Site: 0009TSM - 86-88 Tontine Street, Folkestone CT20 1JP

15th April 2025

Updated review of Risks

Figure 1. Site Layout

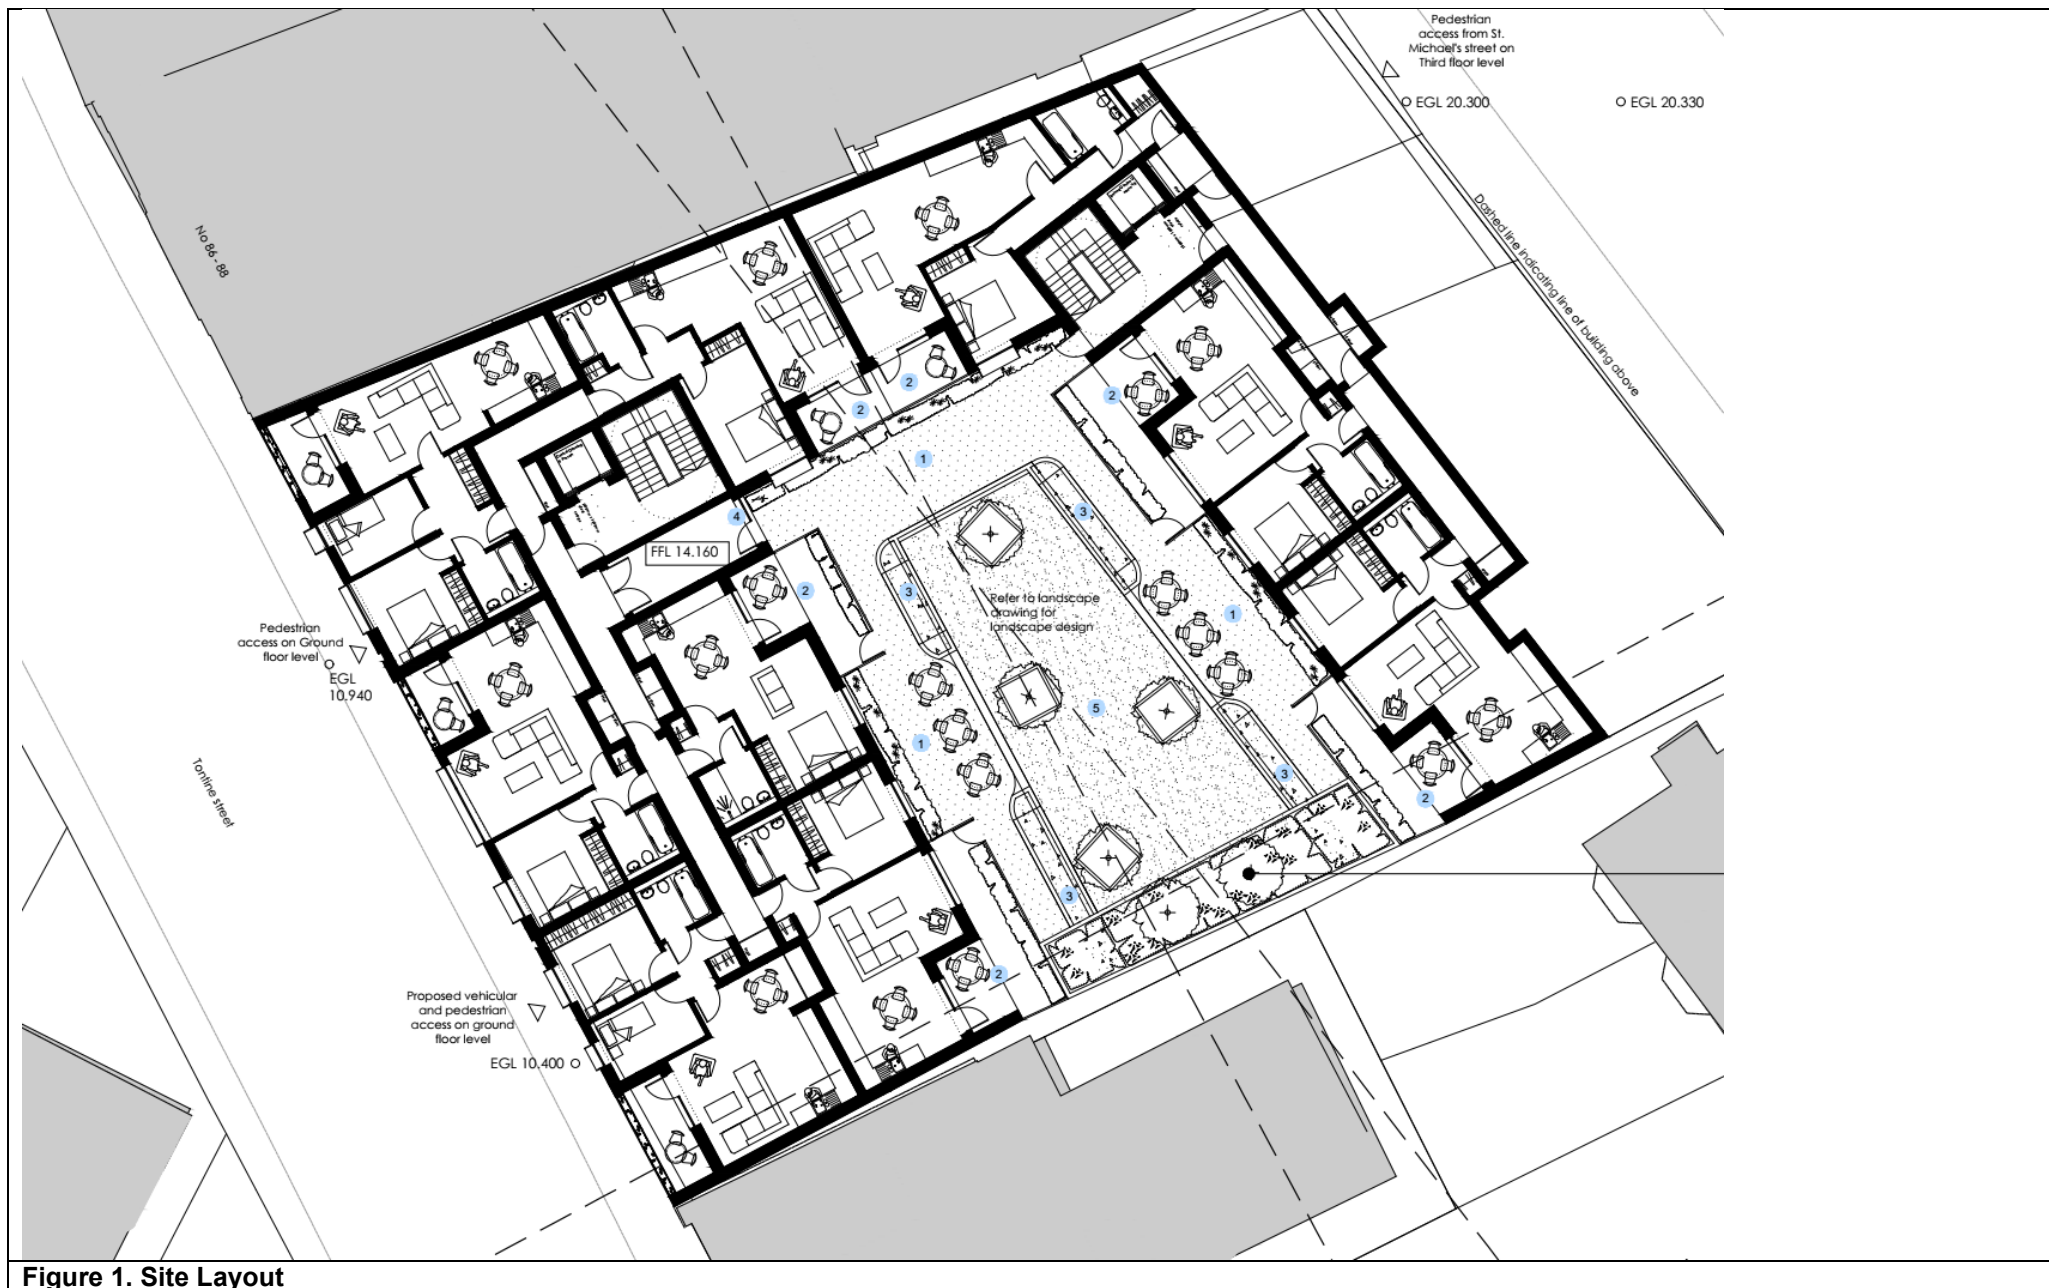
The majority of the site has building footprint present with a soft landscaping restricted to a central courtyard utility area (Figure 1). We would therefore consider consumption of produce to be an unlikely scenario. However, there are potential risks to site users from ingestion and inhalation of soils as dust and dermal contact. Where vapour phase contaminants are present, then intrusion into buildings should be considered. However, the development has an undercroft car park planned (figure 2) under the majority of the site. This will need to have adequate ventilation to prevent the build up of vehicle fumes and by extension will prevent build up of vapour phase contaminants and prevent the presence of a pressure gradient allowing VOCs to enter the building.
